Paper Carrier Tape for Select 0805 Ceramic Surface Mount Capacitors June 27, 2008

Product Update Description

Improved Paper
Tape Solution

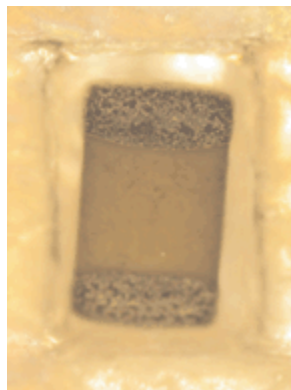
KEMET announces the implementation of paper carrier tape for select 0805 size Ceramic Surface Mount capacitors. This enhancement offers the following benefits:

- Offers improved pick-and-place performance by reducing the movement of the capacitor within the carrier tape pocket (see below)
- Offers a more environmentally-friendly solution than plastic carrier tape, as the paper tape is biodegradable, and
- Brings KEMET in-line with other competitor packaging in the market.

Current Plastic
Tape Solution

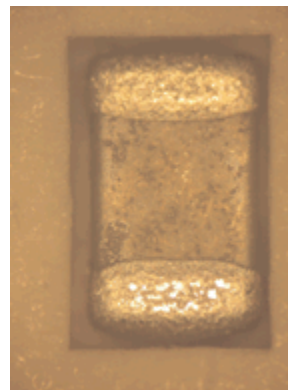
Improved Alignment Within the Carrier Tape
